# Peer Review of Hudson River PCBs Reassessment RI/FS Phase 2 Reports

## Data Evaluation and Interpretation Report Low Resolution Sediment Coring Report

**CHARGE TO EXPERT PEER REVIEWERS**

Fig. D1-1. Water Column PCB Concentrations for Summer-Low Flow Conditions (Transect 6)

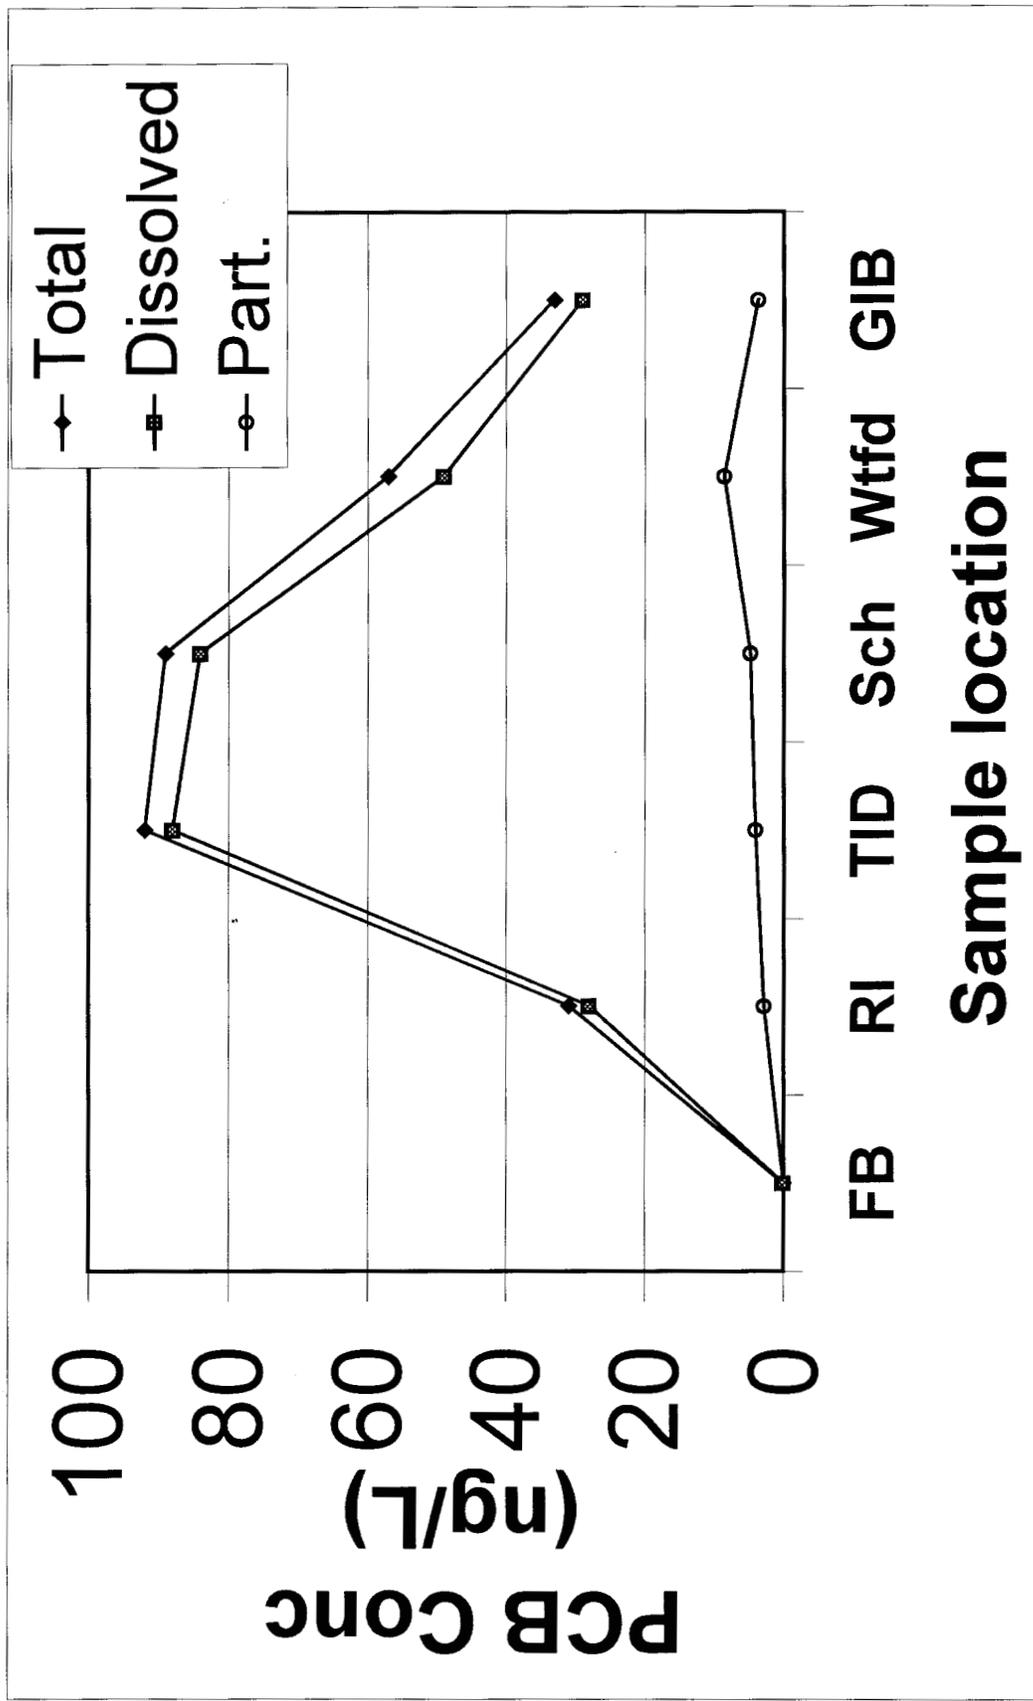
Another confounding factor that complicated interpretation of likely PCB sources, especially for the early 1993 transects (winter low flow and early spring high and transition flow), was the bulk release of Aroclor 1242-like PCBs from the Allen Mills source, reported to have ceased sometime during the middle of 1993. A major source of PCBs during this period was clearly the stretch above Rogers Island. Post 1993 water column data would have been extremely helpful, however, they were never put into a single, coherent presentation that this reviewer could comment on.

The only alternative explanation for these profiles is selective leaching of mono- and dichloro homologs from relatively immobile free product (oil droplets) upstream of the TI Pool. This would also require enhanced or accelerated “dispersion” of these homologs away from the source and a corresponding attenuation of trichloro- and higher homologs (“Tri+”) in sediments upstream of the TI Pool. This scenario, however, would have been observed as a gradual shift in the homolog profile between the upstream Allen Mills source and the head of the TI Pool (Rogers Island). Since the sediments and water column samples collected at Rogers Island had a very different homolog pattern than that within the TI Pool (Figs. C-2 through C-4, and 3-38, 3-40, 3-43 and 3-47), this scenario is not a very likely one.

Fig. D2-1. Estimated Phase 2 log K's show increasing trend with  $\log K_{ow}$  (Hawker and Connell 1988)

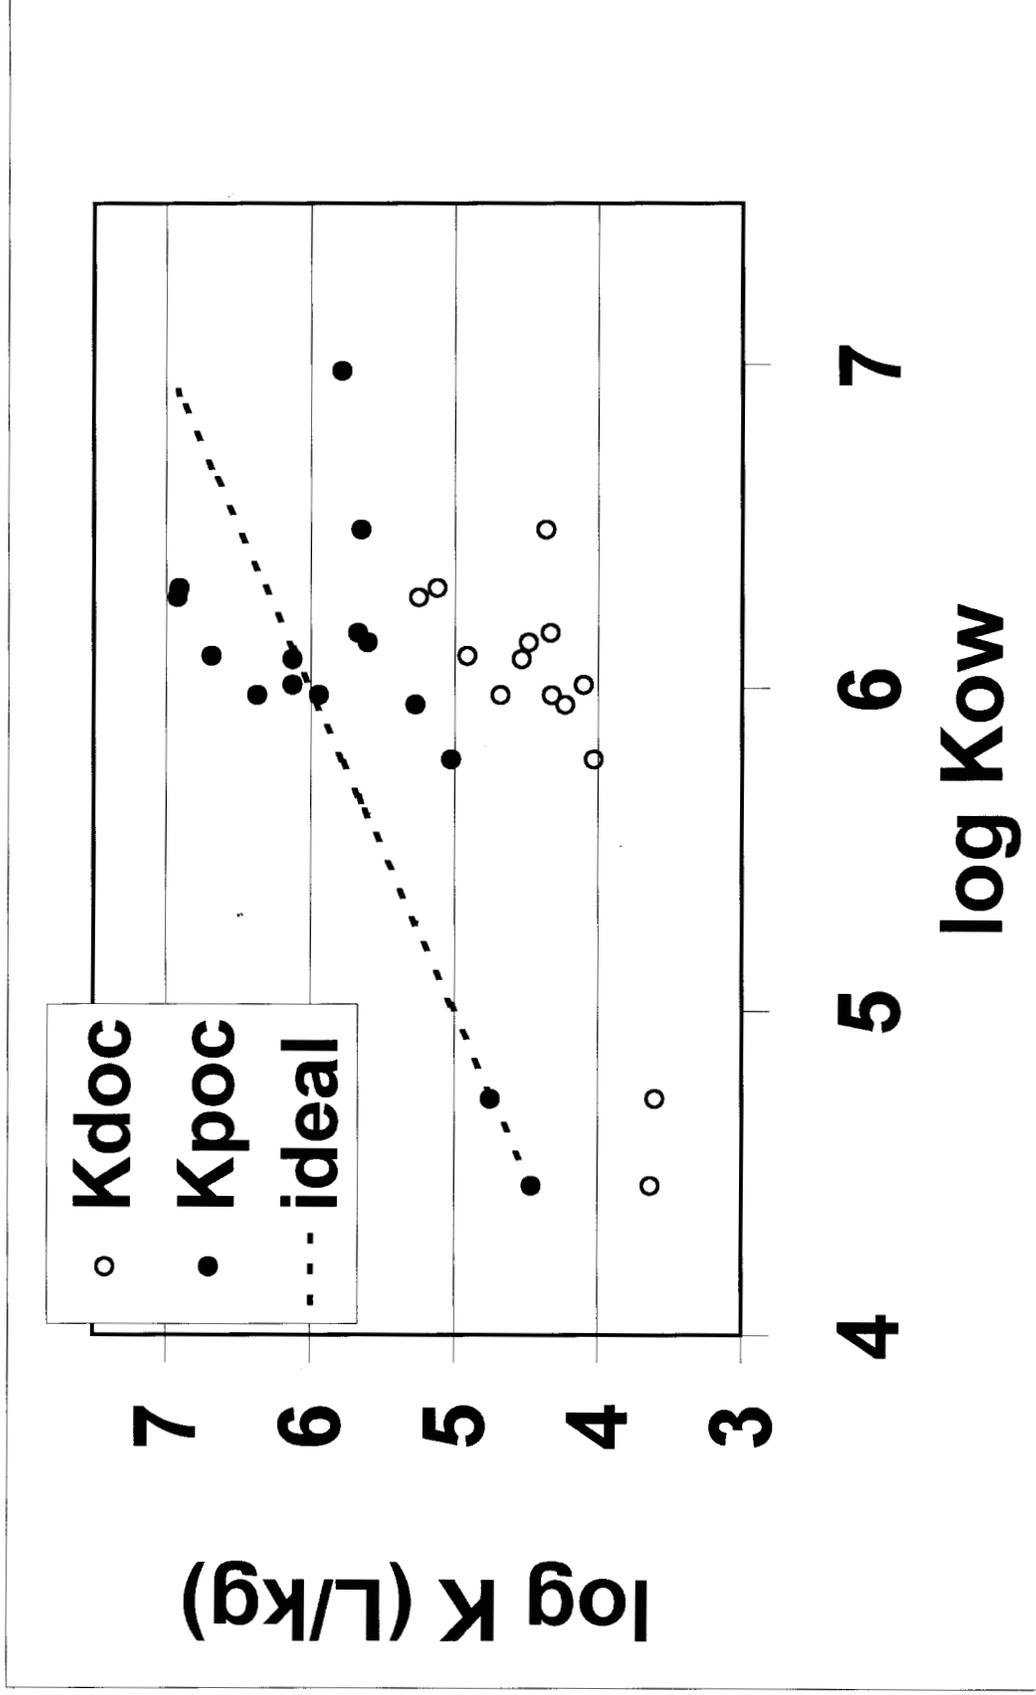
These estimates are presented for partitioning in the water column in Table 3-8 of the DEIR, and appear again as corrected values for bedded sediments (i.e. sediment and porewater distributions) in Table 2-2 of Book 3 of the DEIR Responsiveness Summary. In Table 2-2, K values are given for coeluting congener combinations with  $K_{POC} > K_{DOC}$  without exception. My own analysis of the data show that log K's are positively correlated with log  $K_{ow}$  ( $p < 0.01$ ; see Fig. D2-1 and Table D2-1 below). For New Bedford Harbor sediments, positive  $K_{POC}$ - $K_{ow}$  associations were also noted by Burgess et al. (1996) and Brownawell and Farrington (1986). However, in Table 3-8, one curious exception is noted for BZ#8, where the estimated  $K_{POC}$  (5.19) is less than  $K_{DOC}$  (5.43). No explanation is given for this unique trend reversal, other than the fact that footnote "c" in Table 3-8 indicates some sort of blank problem. It is not clear if the congener specific results in Table 3-8 will be used in the future. If they are, I suggest that values for BZ#8 be revisited. If the data for BZ#8 turn out to be of questionable quality, interpolation or regressions based on aqueous solubility or  $K_{ow}$ , should be considered to estimate K values for this congener. For any future predictions of K, a quick check of the trend with increasing chlorines (or log  $K_{ow}$ ) can be performed as a quick sanity check of the model.

On a more general note, it is not clear why all the effort was made to model the effects of DOC, especially since it was noted in the original version of the DEIR that DOC was fairly constant at ~5 mg/L in the water column. If these data were accurate, then one can conclude that DOC in the water column would exert a relatively constant and predictable influence in terms of partitioning. A case can be made that DOC in porewater of fine-grained sediment, although higher, would be relatively constant as well. In fact, in the example given in the DEIR Responsiveness Summary, Book 3, DOC was estimated @ 34 mg/L, ~10 times higher than that measured/assumed in the water column. The high degree of uncertainty in modeling the effects of DOC make it more of a mental exercise and less of a practical tool for modeling. The danger also exists that "over-manipulation" of model parameters such as partitioning constants can be abused to better fit *in situ* values.

I would thus recommend simplifying the partitioning model back to a 2-phase model instead of a 3-phase model. In the 2-phase model, DOC would be included as a more-or-less constant influence in the apparent or operationally defined dissolved phase.

Fig. D3-1. Model of PCB loading and downstream transport.

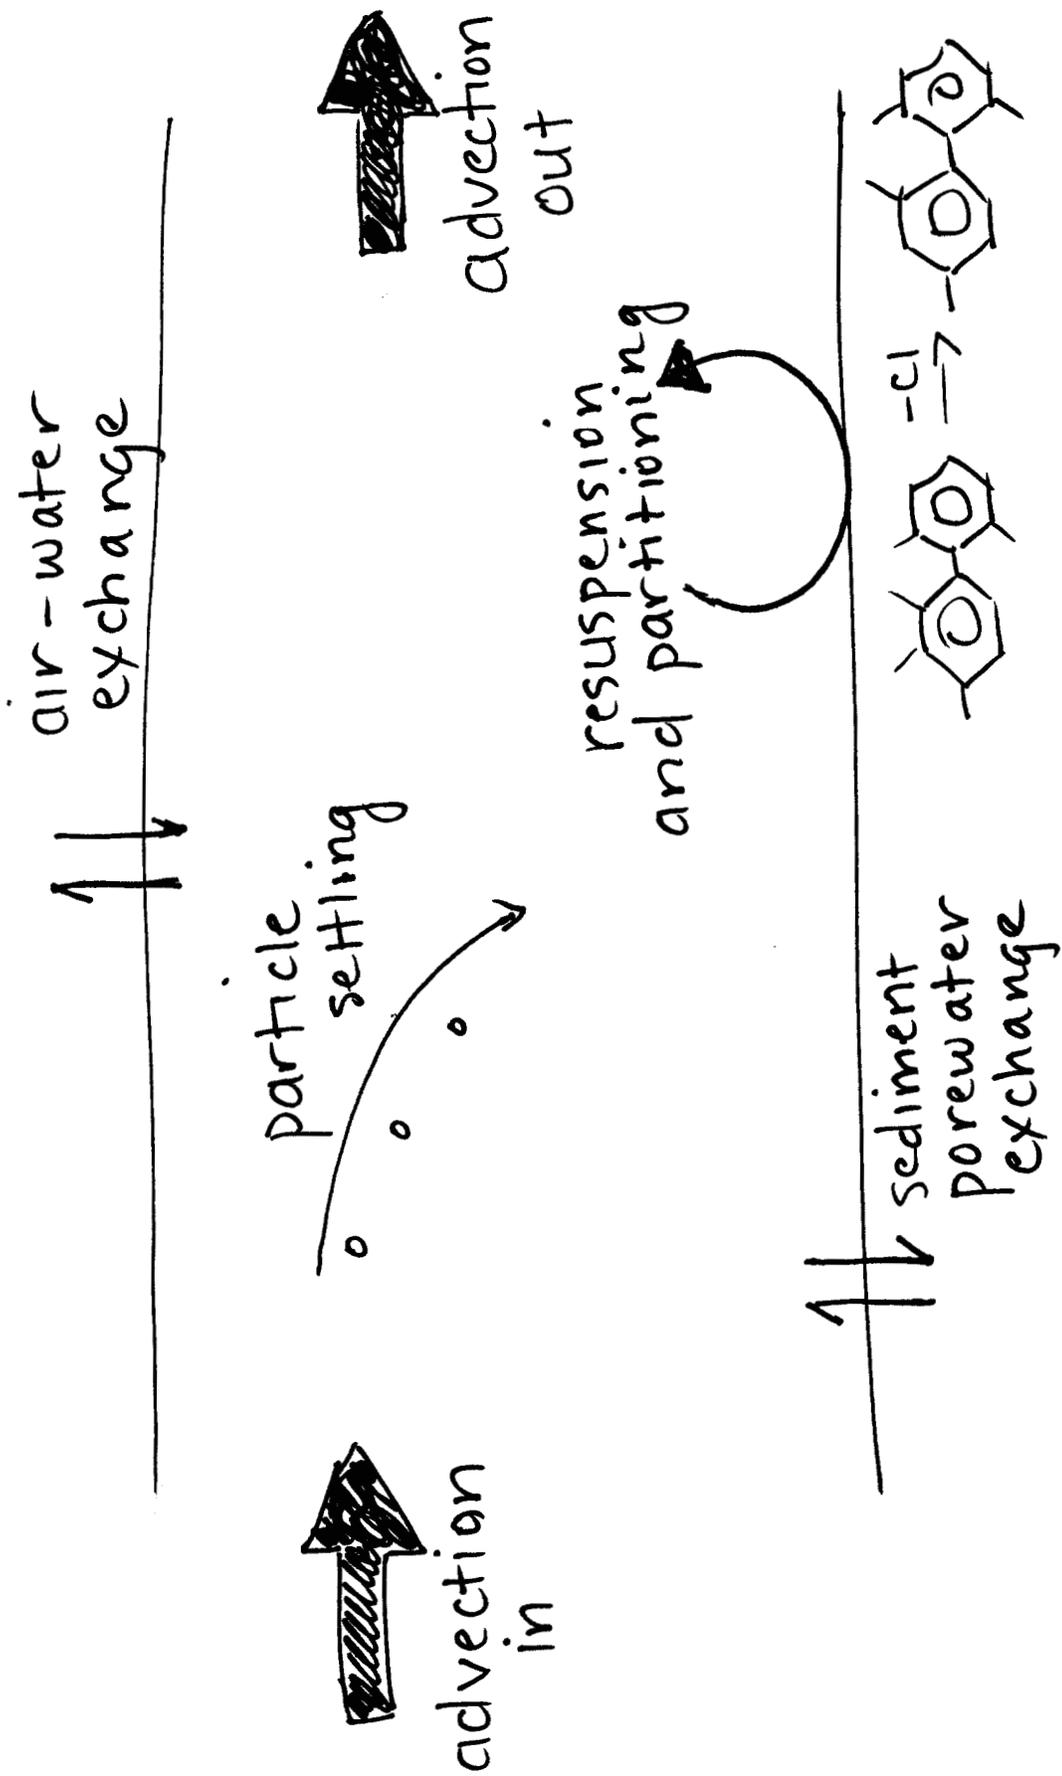
Because of their physicochemical properties including aqueous solubility and Henry's Law constants (see Fig. D3-2 below), mono- and diCBs will preferentially partition into the dissolved phase and into the atmosphere relative to heavier homologs. If air above the Hudson River is undersaturated, a constant flux of PCBs to the atmosphere can act to continually pull PCBs from the source (sediment) into the water column so that a concentration gradient is maintained.

More limnological data (e.g. residence times; chlorophyll *a*, temperature gradients/stratification during summer low flow conditions) would likely improve our understanding of the processes at work in the TI Pool. For example, this stretch would seemingly act much more like a lake than upstream and/or narrower stretches of the Upper Hudson. As such, the processes acting on PCBs that are enhanced under lake-like conditions will be most important. The larger surface area to volume, increased residence time and quiescent flow regimes would likely result not only in greater fluxes of PCBs out of sediments and into the water column, but also into the air! Mass transport between phases is dependent both on the magnitude of the concentration gradient and surface area. The increased dissolved phase PCBs thus provide a larger driving force for transport out of the water column into the air. This flux would increase under summer, low-flow conditions when both air and water temperatures are at their annual maximum.
